WATER PERMIT NO. 2126-2

WATER PERMIT APPLICATION NO. 2126-2 WARD DAM PROJECT

REVISED REPORT
ON APPLICATION NO. 2126-2
U. S. FOREST SERVICE
July 16, 1990

SD-091-01
WARD DAM
SITE PLAN, MARSH DATA, PROFILES

DUCKS UNLIMITED INC. GREAT PLAINS REGIONAL OFFICE	PROJECT NO. SD-091-01	DESIGNED BY: RCS
	WARD DAM	DRAWN BY: TSP
	WATER CONTROL STRUCTURE-PLAN, PROFILE, & DETAILS	SURVEYED BY: GLJ
	CHECKED BY:	APPROVED BY:
DATE: MARCH 27, 1990	SHEET NO. 4 OF 5	APPROVED BY:

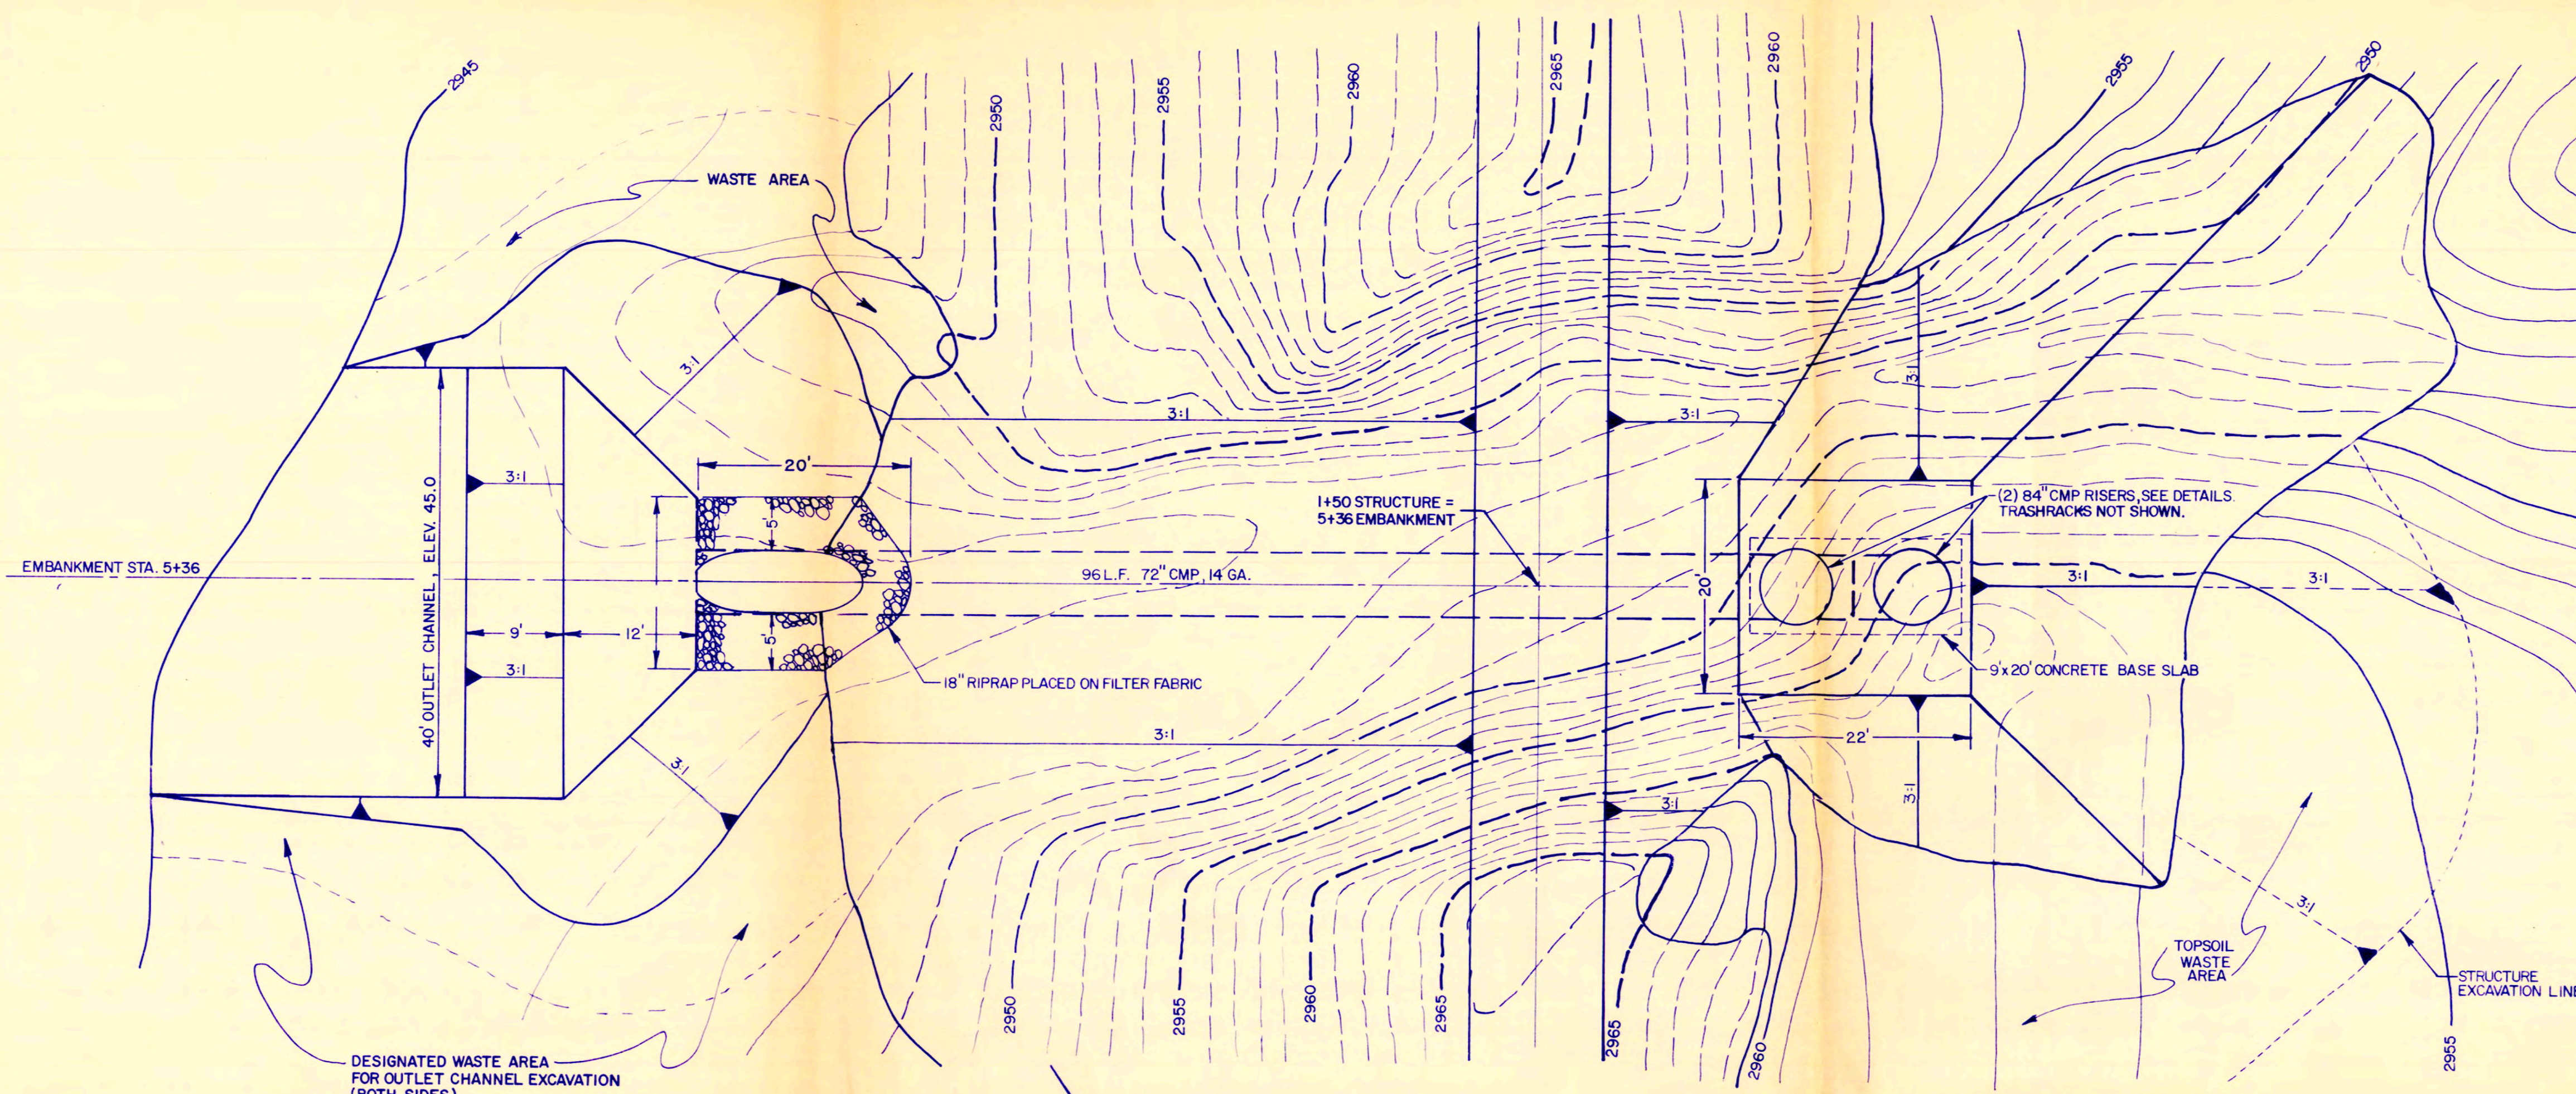
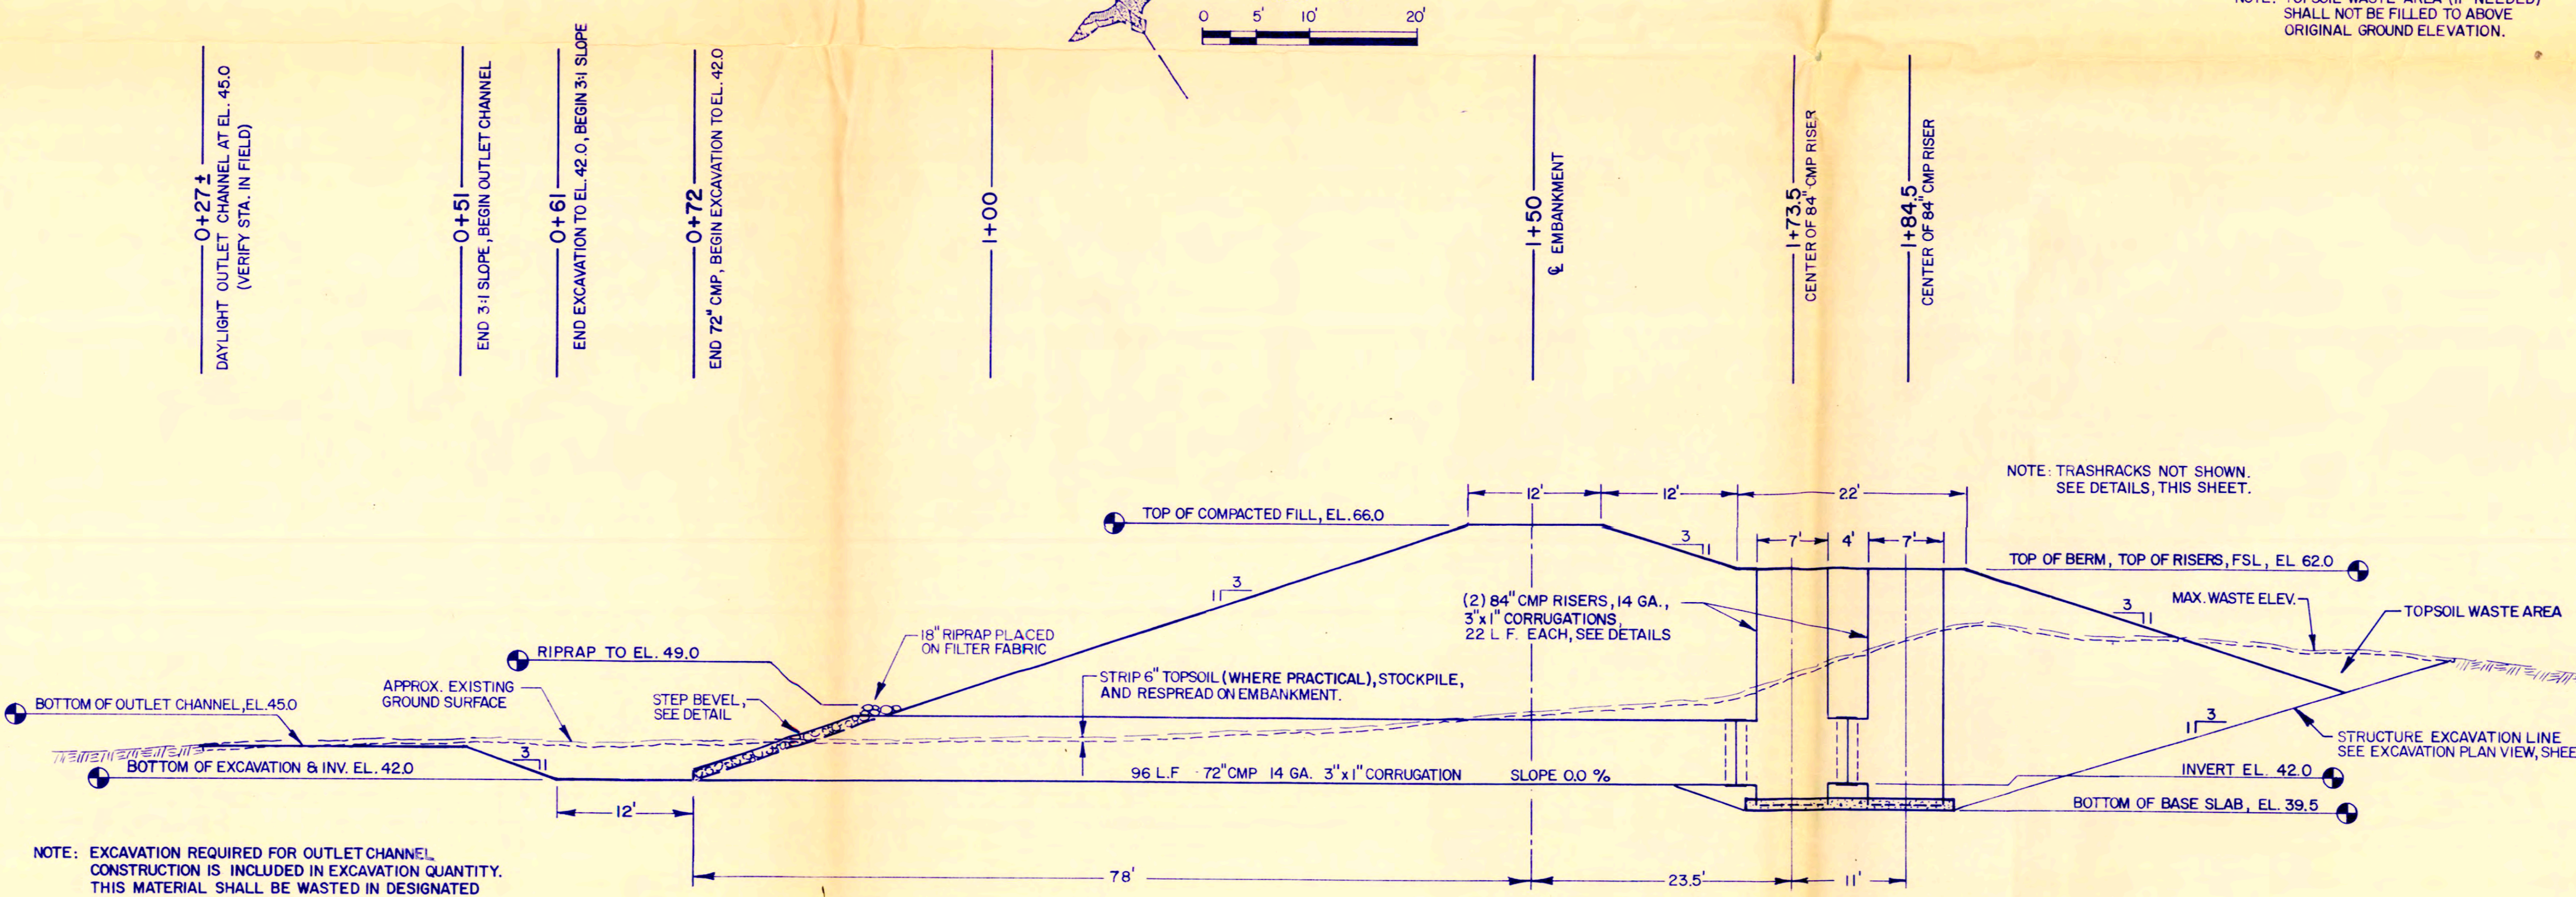
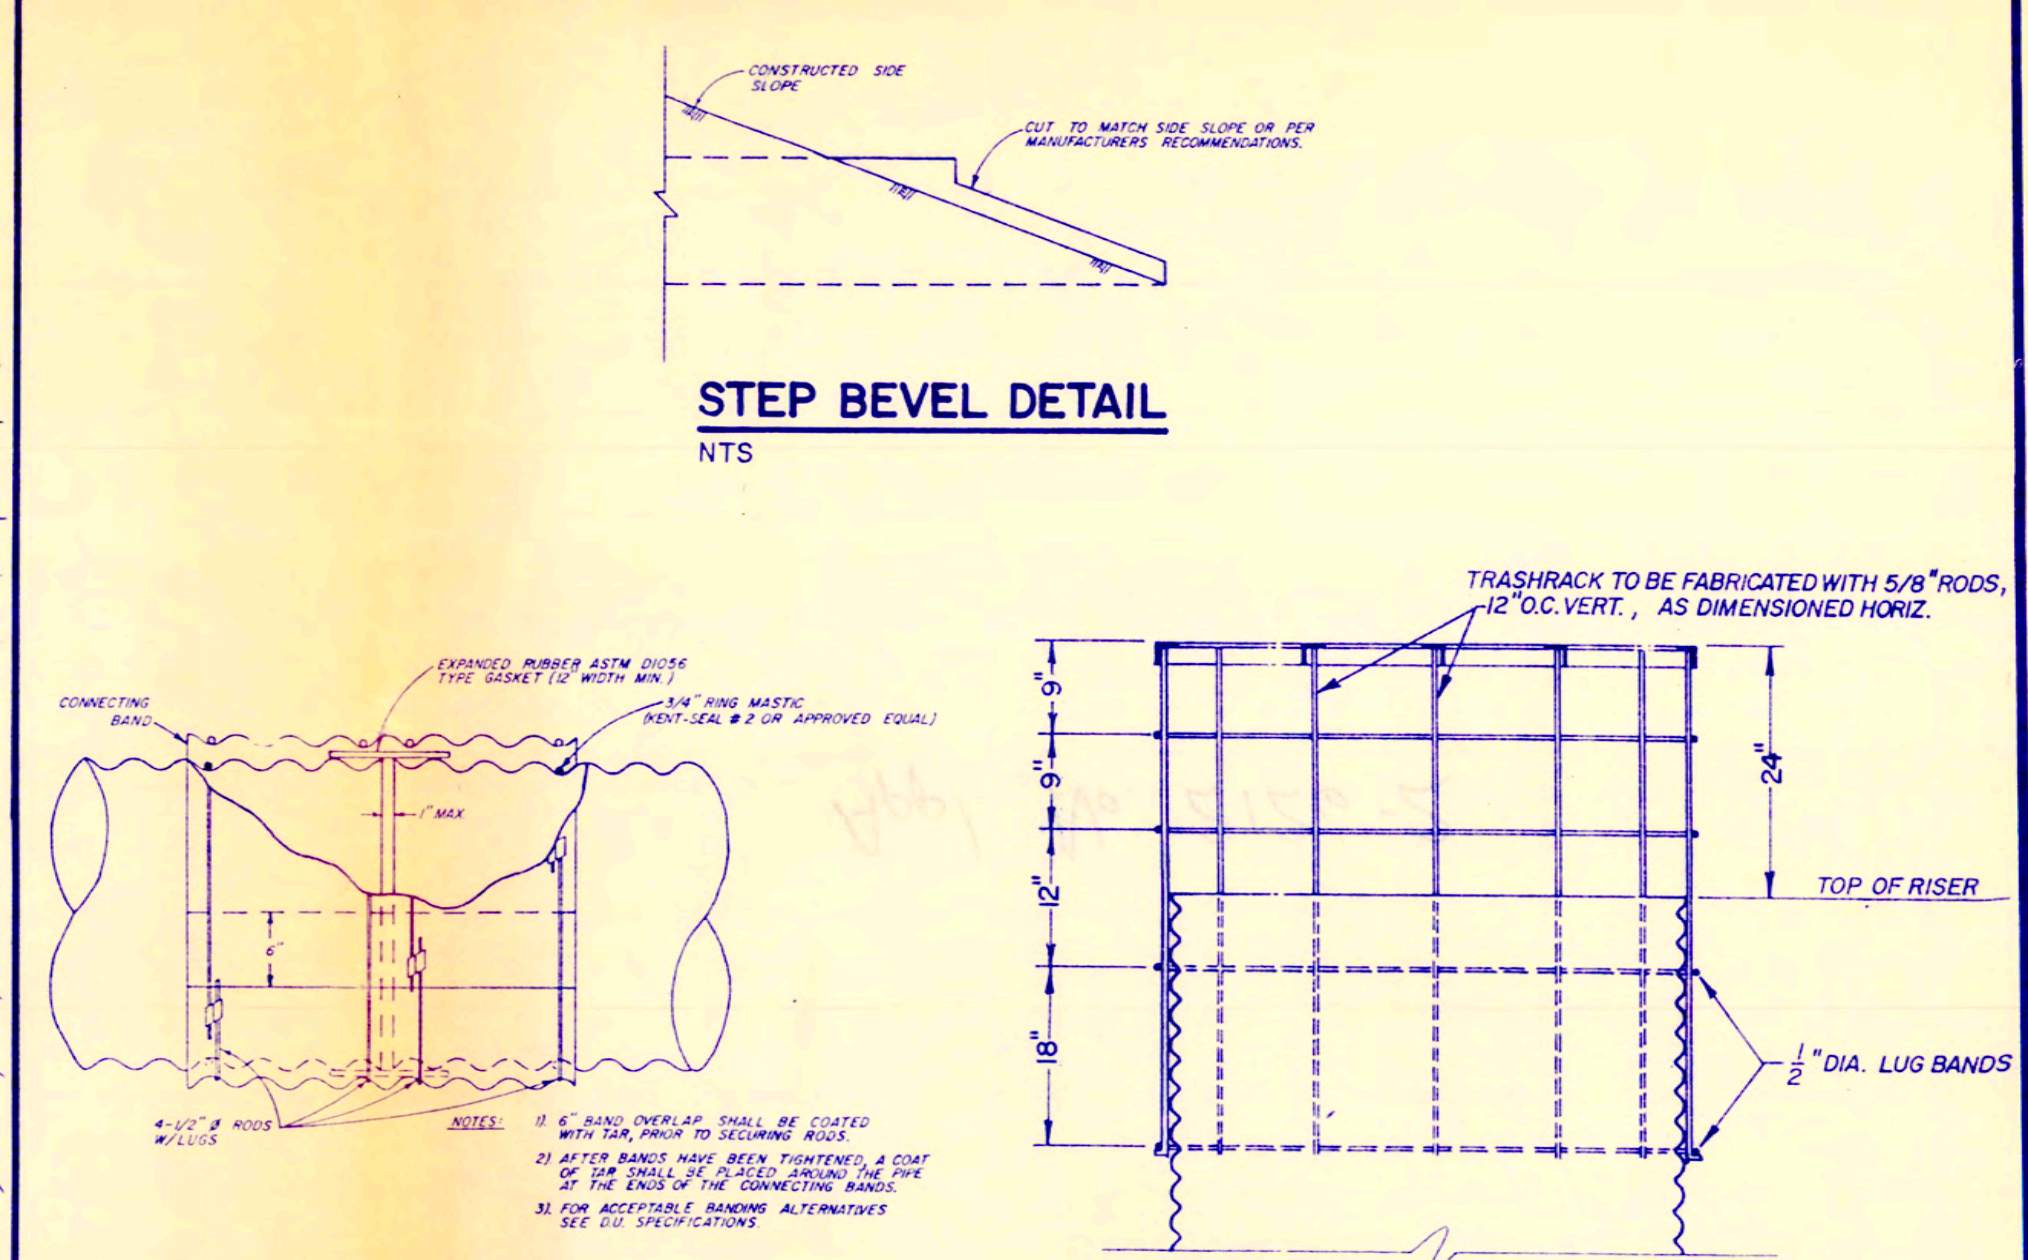
We have reviewed the revised plans for the Ward Dam Project in Pennington County, South Dakota. These plans include the installation of a 6 inch gated conduit at elevation 2956.0 to serve as the structure's low level outlet. The plans as submitted are approved.
